ADDENDUM NO. 01

**Bid #1472 Campus Entrance Improvements Phase 2
at
Santiago Canyon College**

Project ID #3742, DSA #04-122457

March 13, 2025

FOUNTAIN
ELECTRICAL
PLANS &
DETAILS

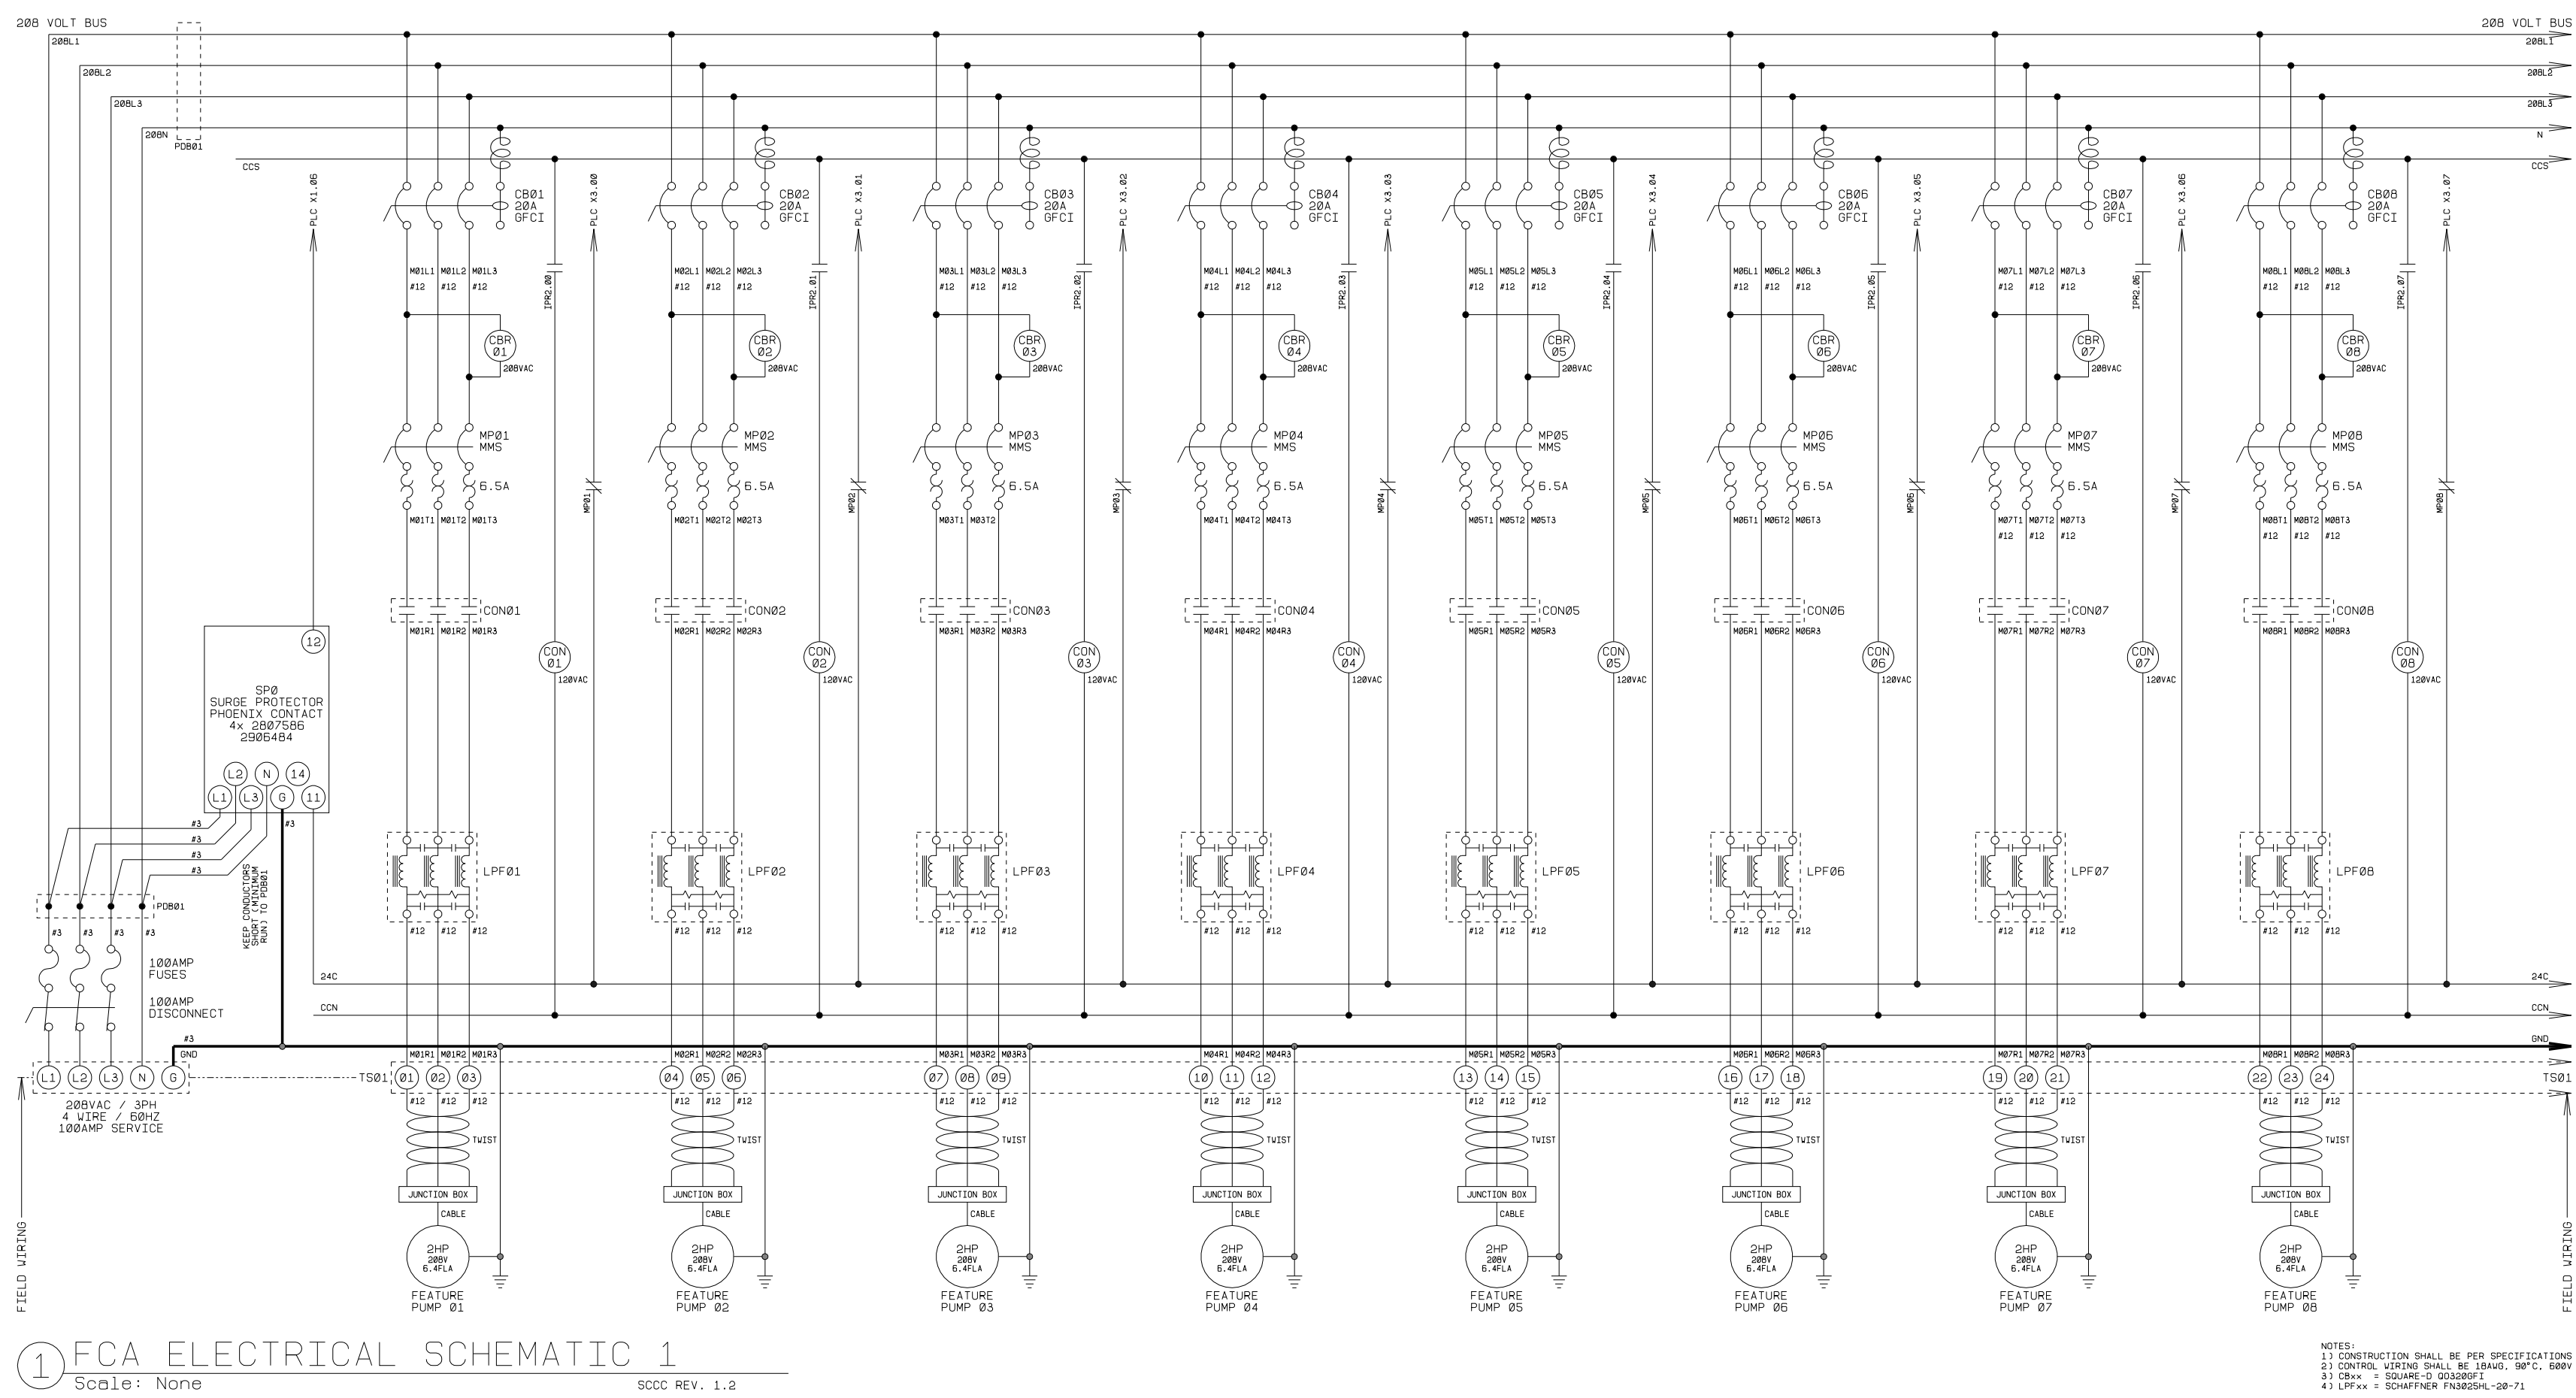
PROJECT NAME:	Campus Entrance Improvements Phase 2 Project at Santiago Canyon College		
PROJECT NUMBER:	3742	BID NUMBER:	1472
EMAIL TO: facilitiesbid@rsccd.edu			
DATE:	3/5/2025		
FROM:	Ryan Agnew - RJR Water Features	EMAIL:	ragnew@rjrwaterfeatures.com
SPEC SECTION:	Electrical/Controls	DRAWING NUMBER:	F-1.06 & F-1.07
REQUESTED CLARIFICATION:			
<p>The equipment load schedule on F-1.06 and the electrical schematic on F-1.07 do not match.</p> <p>F-1.06 matches the equipment shown throughout the plans, while F-1.07 has multiple additional items not shown on the plans.</p> <p>Please advise if a revised electrical schematic will be provided.</p>			
RESPONSE TO CLARIFICATION:			
<p>Please use Addendum 2, revised electrical sheets F-1.05, F-1.06, and F-1.07.</p> <p>SVA, 3/13/2025</p>

PROJECT NAME:	Campus Entrance Improvements Phase 2 Project at Santiago Canyon College		
PROJECT NUMBER:	3742	BID NUMBER:	1472
EMAIL TO: facilitiesbid@rsccd.edu			
DATE:	3/5/2025		
FROM:	Ryan Agnew - RJR Water Features	EMAIL:	ragnew@rjrwaterfeatures.com
SPEC SECTION:	Electrical/Controls	DRAWING NUMBER:	F-1.06
REQUESTED CLARIFICATION:			
<p>Clarification is needed on the fountain lighting controls. Is the fountain control panel providing power AND control for the lights located in the fountain basins, or are the lights being controlled by an external controller?</p>			
RESPONSE TO CLARIFICATION:			
<div style="border: 2px solid green; padding: 10px; margin-top: 10px;"><p>The fountain control will provide lighting power. Please use Addendum 2, revised electrical sheets F-1.05, F-1.06, and F-1.07.</p><p>SVA, 3/13/2025</p></div>

- A. **F-1.05 – Detail 1:** The wiring and conduit for the light power supplies have been relocated to the West J-box for ease of installation.
- B. **F-1.05 – Detail 2:** Filter pumps have been included in the detail.
- C. **F-1.06 – Detail 1:** The electrical plan has been updated to reflect new light fixtures and power supply layout. The originally specified lights are no longer available.

- D. **F-1.07 – Details 1 thru 4:** The electrical schematics have been updated to include the three new lighting circuits.
- E. **F-1.07 – Detail 2:** Float switch detail has been included.
